## **ADDENDUM #2**

### **RFP No. 303**

## **EXTERIOR REPAIRS TO THE THOMAS J. MOYER OHIO JUDICIAL CENTER**

**Date of Issuance: February 12, 2026**

**Figure 1:** Concrete substrate needing replacement

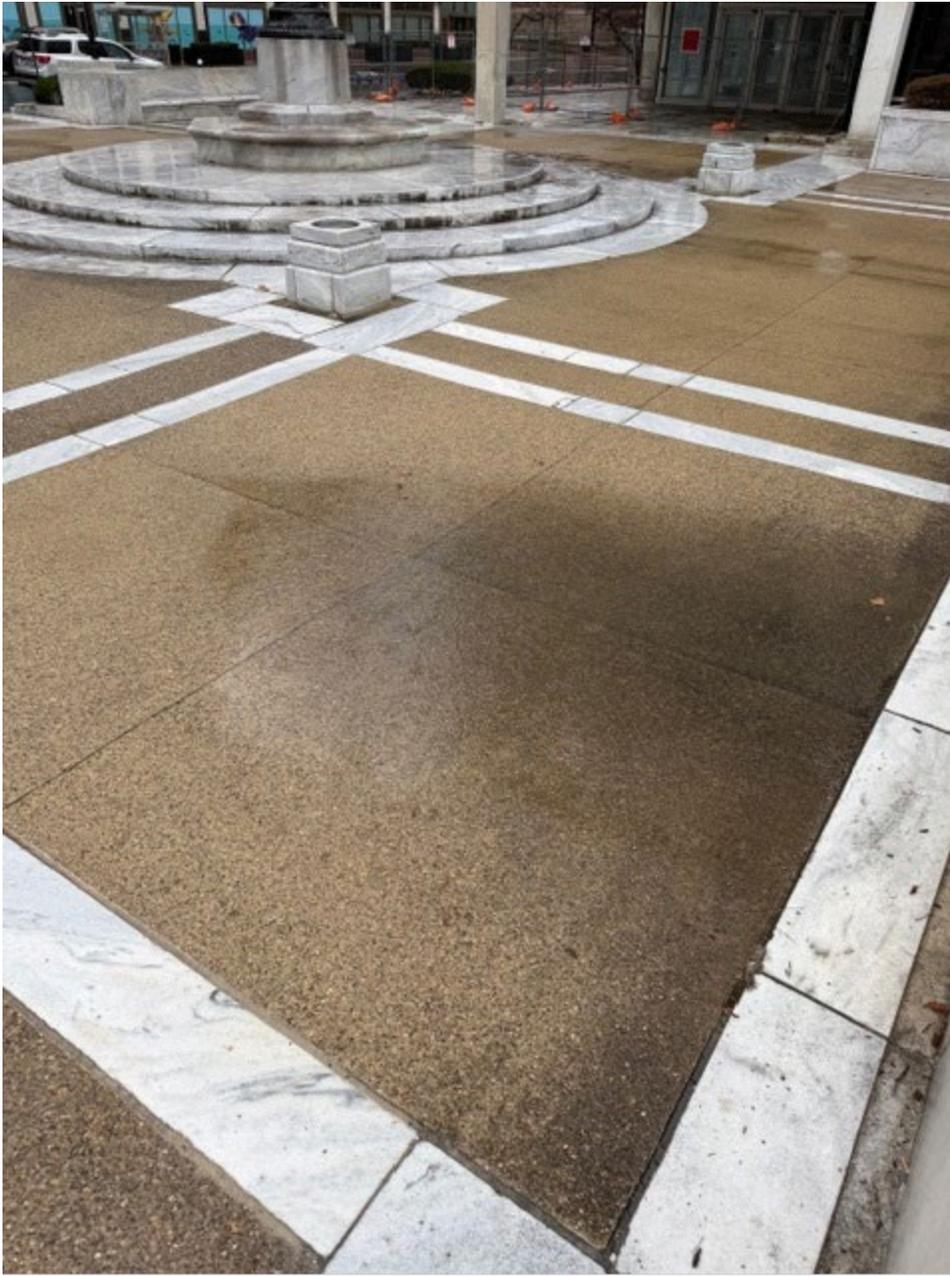
6. Replacement of four slabs of exposed aggregate concrete due to trip hazards and water puddling
  - a. Two sections measure 83” x 82”
  - b. Two sections measure 85” x 83”
  - c. All sections are approximately 4 inches thick.
  - d. Aggregate concrete should be of similar type and material currently in use, see attached Figures 1 and 2.
